# COVER SHEET

Mark-up Legend	
Building Review	
Engineering Review	
Fire Review	
Planning Review	
Public Works Review	
Traffic Review	
APPROVED	
BY	CITY OF PUYALLUP DEVELOPMENT ENGINEERING
DATE	
NOTE: THIS APPROVAL IS VOID AFTER 180 DAYS FROM APPROVAL DATE. THE CITY WILL NOT BE RESPONSIBLE FOR ERRORS AND/OR OMISSIONS ON THESE PLANS. FIELD CONDITIONS MAY DICTATE CHANGES TO THESE PLANS AS DETERMINED BY THE DEVELOPMENT ENGINEERING MANAGER.

FOR  
**ARCO ampm PUYALLUP**  
SEC. 33, TWN. 20 N, RGE. 4 E, W.M.  
CITY OF PUYALLUP, PIERCE COUNTY

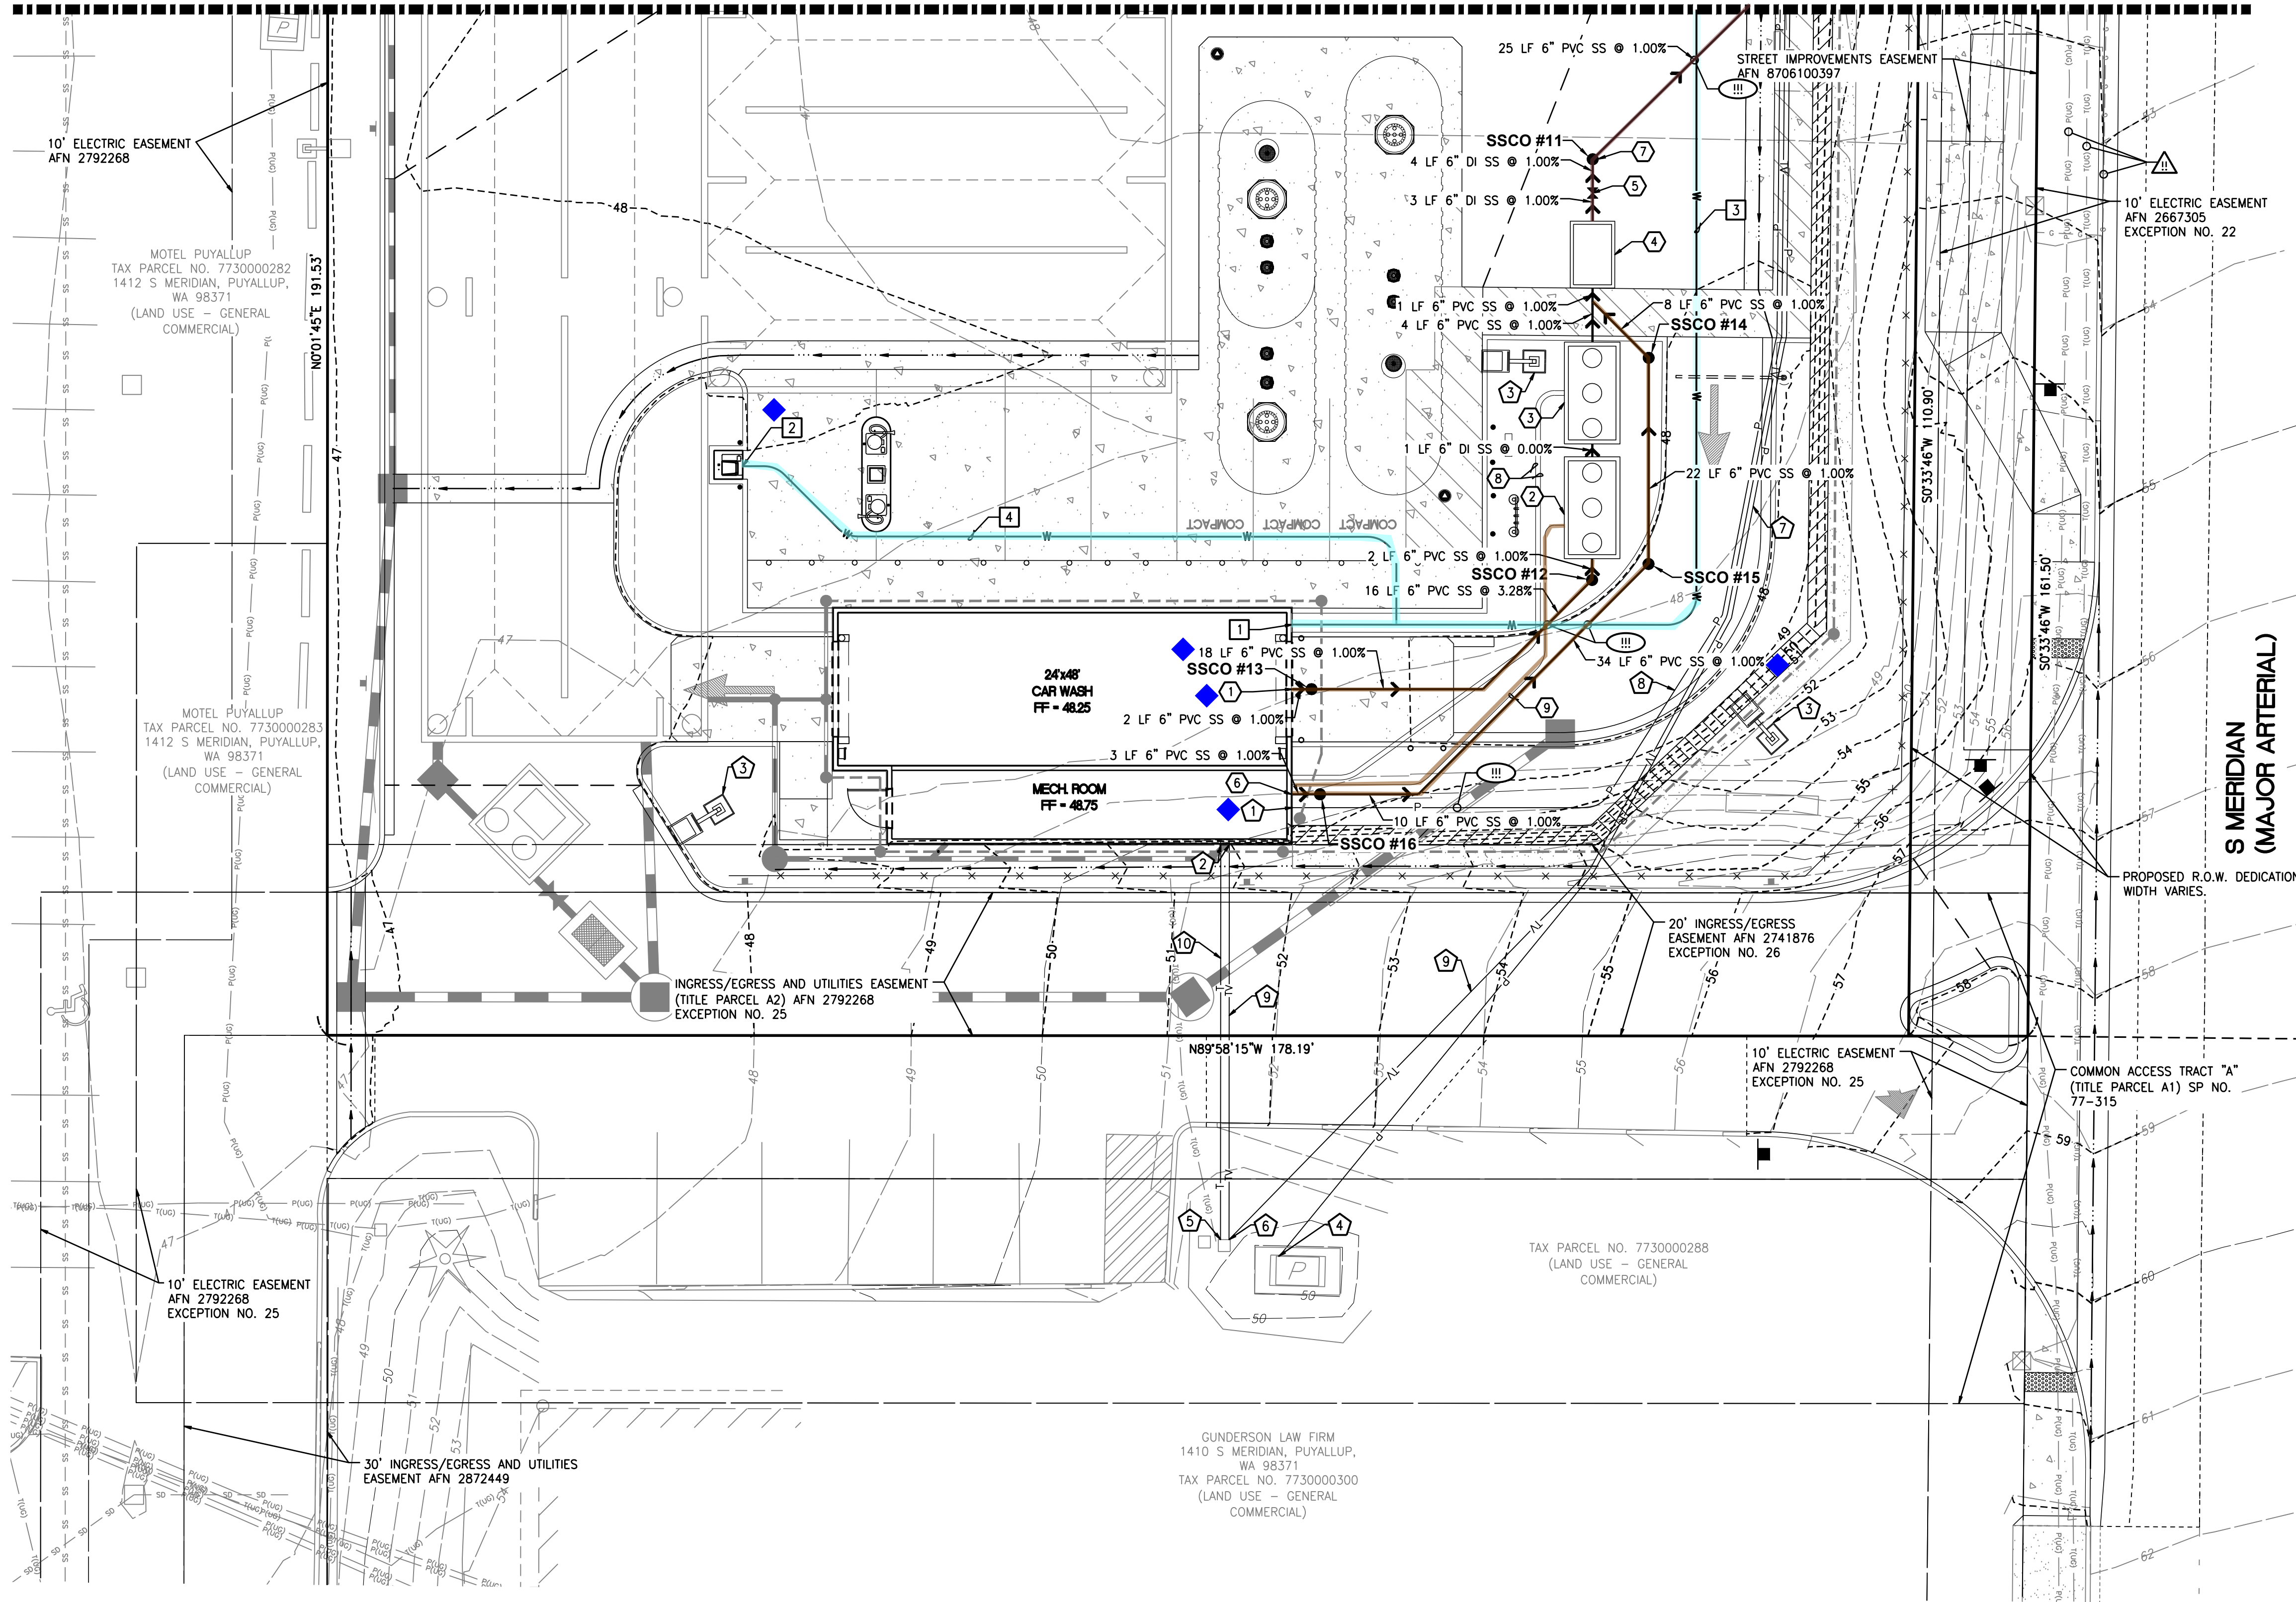
- This note appears to be discussing reclaim from tank #3 instead of tank #1. [civil plans, sheet C6.1]

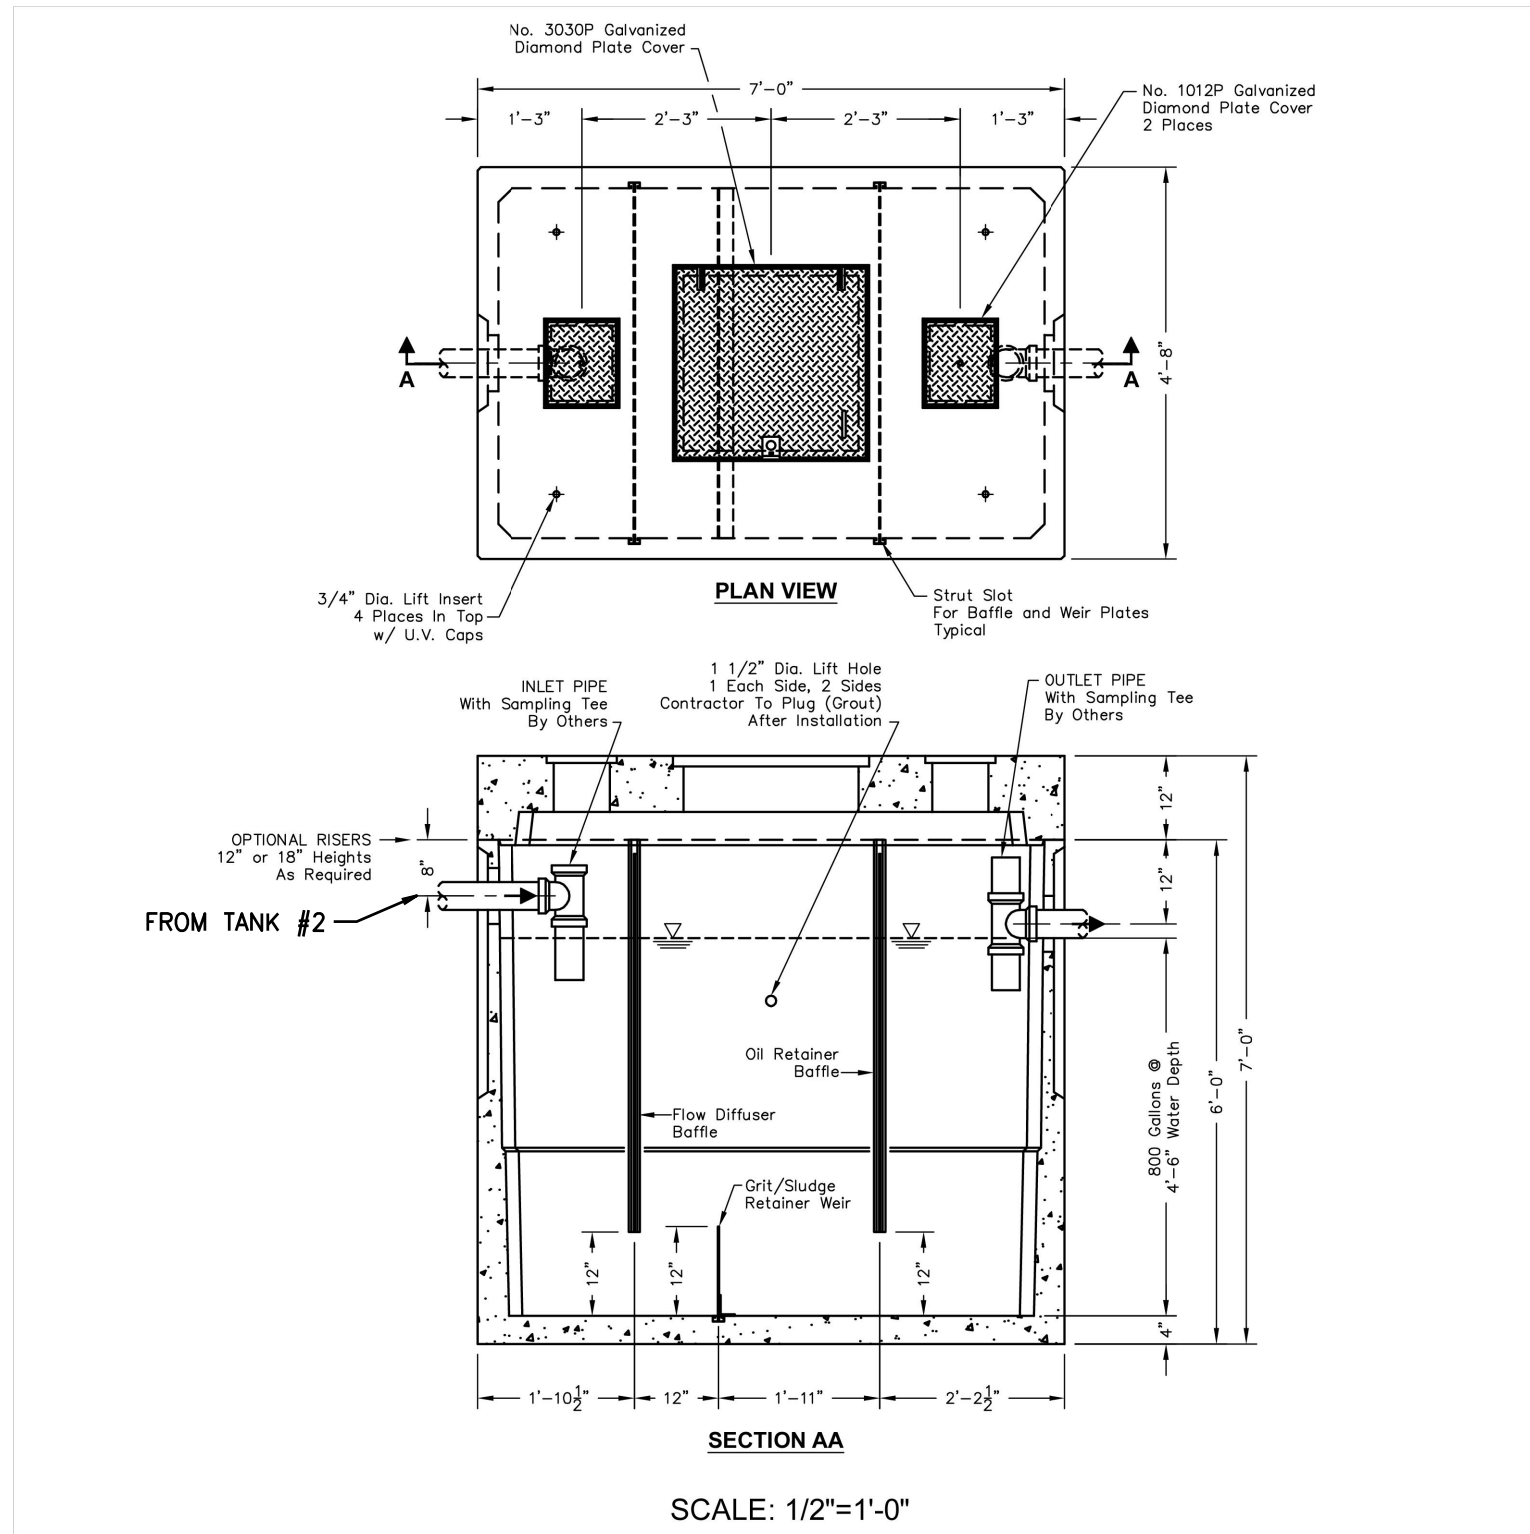
This sentence is discussing grease interceptor sizing rather than oil/water separator sizing. Revise accordingly. [civils, sheet C6.5]

4 CITY OF PUYALLUP SEWER MAIN TAP  
C6.4 SCALE: NTS

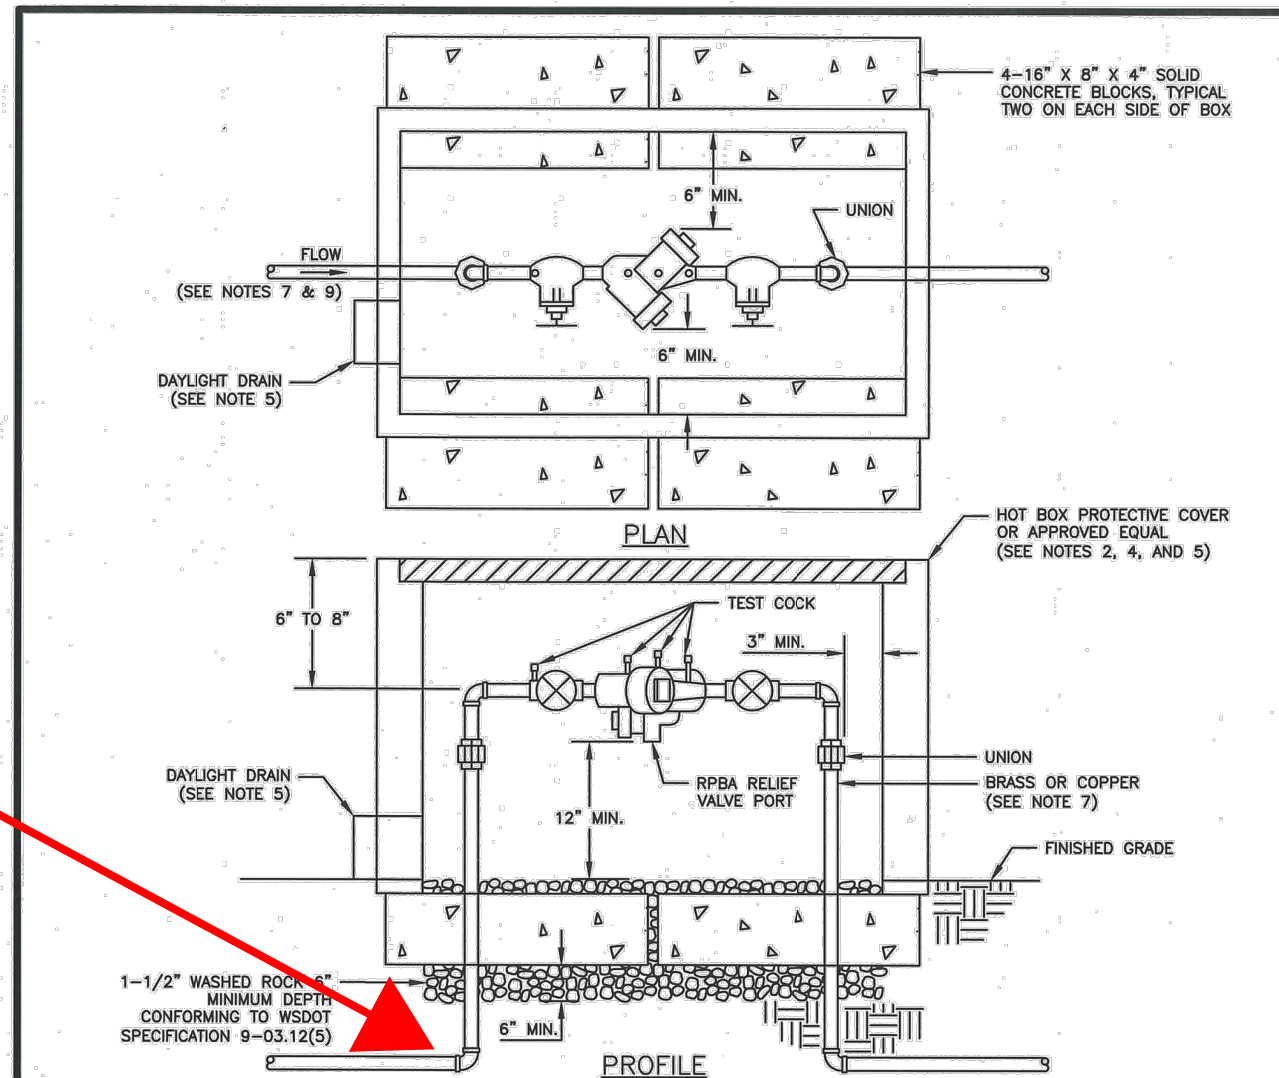
Include city standard detail 03.01.03-1 Water main crossing other utilities. [civils, sheet C6.4]

Include city standard detail 06.01.01 Pipe trenching bedding and backfill. [civils, sheet C6.4]
